**Re: Notice of Violation at Northwoods Commercial Development/Franklin County
Permit #4GC02792*AG**

This letter is written in follow up to a construction storm water inspection by Katie Anderson and Rachelle Howe, of the Ohio EPA, at Northwoods Commercial Development located east of the Northwoods Boulevard and High Street intersection on July 23, 2009. The purpose of the inspection was to evaluate compliance with the General Storm Water Permit Associated with Construction Activities. During the inspection, the following was noted:

Figure 1

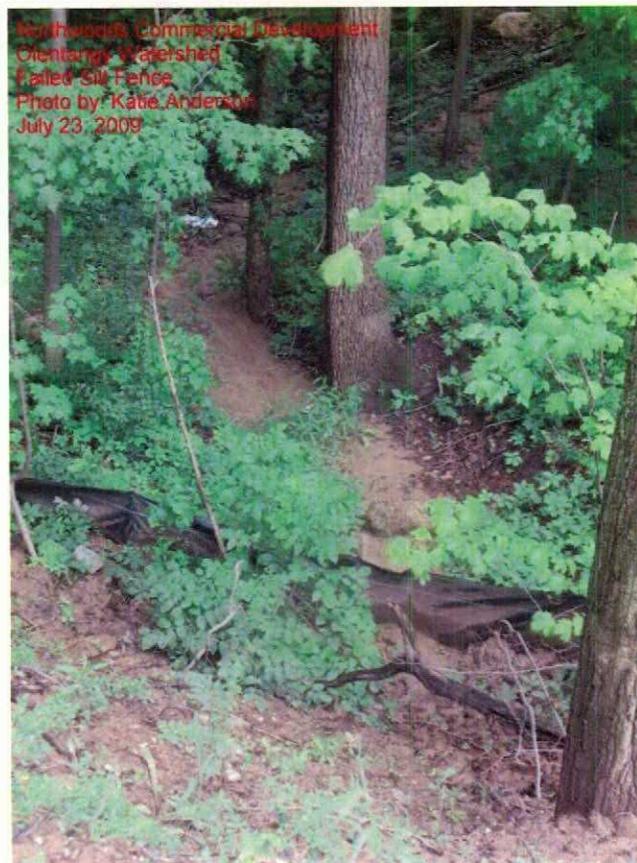
- It was noted that the silt fence protecting the stream has failed in multiple locations, (See Figure 1). Adjacent to the check dams, the silt fence was installed incorrectly as it was not entrenched, (See Figure 2). This has allowed sediment to bypass the fence and exit the site.
- The sediment controls implemented on this site will require maintenance or reinstallation to ensure a proper functioning condition. This general permit states that all sediment controls will be inspected and maintained every seven days or within 24 hours of a precipitation event equal to or greater than 0.5 inches. A log of inspection must be maintained on site for the agency to review.
- Due to the large amount of drainage area, (see Figure 3), additional measures, such as straw bales, are expected to support and strengthen the silt fence or demonstrate an approvable alternative.
